Delegated Report

Householder Planning Application

Application No:	20221244
Location:	49 Hillside Avenue, Gravesend, Kent, DA12 5QN
Description:	Erection of a part one storey/two storey side and rear extension incorporating alterations to the roofline and creation of a vehicle crossover
Applicant:	Mr Ademola Atobaru
Site Visit:	N/A Desktop Assessment

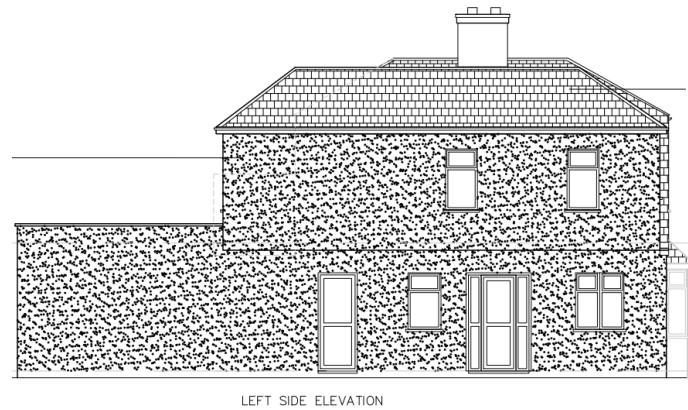
Although set-down from the ridge, this is only marginal and the side extension projects beyond and overhangs the flank wall of the property. It also extends beyond the rear elevation of the property creating a two storey rear extension. It is an incongruous and disproportionate addition that introduces a large flat roof section on the extension which is out of character with the roof design of the existing dwelling. The Local Planning Authority do not support applications proposing flat roofs above single storey level by virtue of their bulky and incongruous appearance, and the SPD clearly states that they will not be supported on the side where clearly visible from the street. Therefore, the side extension fails to respect or respond to the original characteristics of the property due to its size and design, as well as introducing a bulky flat roof.

The rear extension is not visible from any public vantage point and will have no impact on the street scene. However, the height of the extension by virtue of the parapet wall is considered to be excessive and the design of the extension could be improved by reducing the height and removing the parapet wall. The extension would also benefit from a reduction in depth to keep the extensions more proportionate to the existing dwelling.

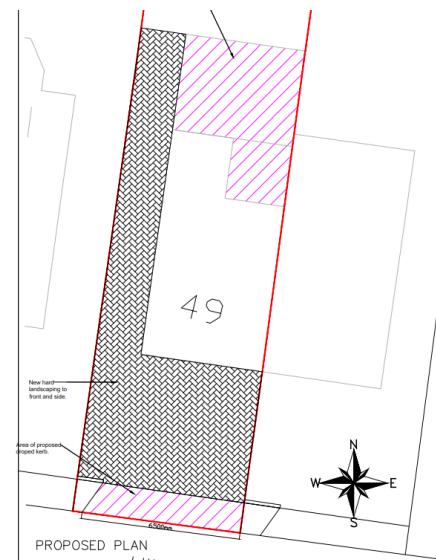
The driveway would occupy the entire frontage of the property, with the hardstanding extending up the side of the property. There are no elevation drawings or sections provided, however due to the topography of the land it is assumed that the driveway would be sloping down to the highway. This would involve the removal of all soft landscaping on the frontage.

In terms of the driveway, the plans indicate that the frontage of the property would be hard-paved, even though no details have been provided regarding the materials used in the formation of the driveway. No details have been provided in terms of whether the driveway will be sloping or excavated out to be level. The existing front garden is soft landscaped with mature trees and shrubs occupying the frontage, which would be removed to facilitate the driveway. The lack of soft landscaping is considered to be poor design and harmful to the character of the street scene, contrary to guidance given in Gravesham’s newly published Householder Extension/Alteration Design SPD (2021). The SPD clearly states that hardstanding should be proportionate and soft landscaped planting should be provided:

This is not the case with this application and the proposed development would result in a harsh, overdeveloped appearance which is harmful to the character and appearance of the street scene. Furthermore, any development should result in a net gain of biodiversity to accord with Section 15 of the NPPF (2021). The proposed driveway would remove all landscaping and replace it with hardstanding, which represents a significant loss of biodiversity contrary to Section 15 of the NPPF (2021).

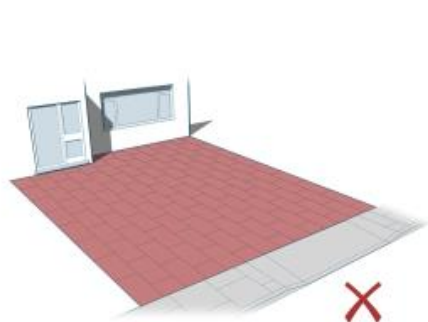
Whilst it is noted that the adjoining dwelling has a flat roof dormer extension, this dormer is significantly smaller and is proportionate to the host dwelling in terms of scale and is set within the roof slope. Therefore, although the neighbour has extended the roof space, the dormer is not a justification for the excessively bulky addition hereby proposed.
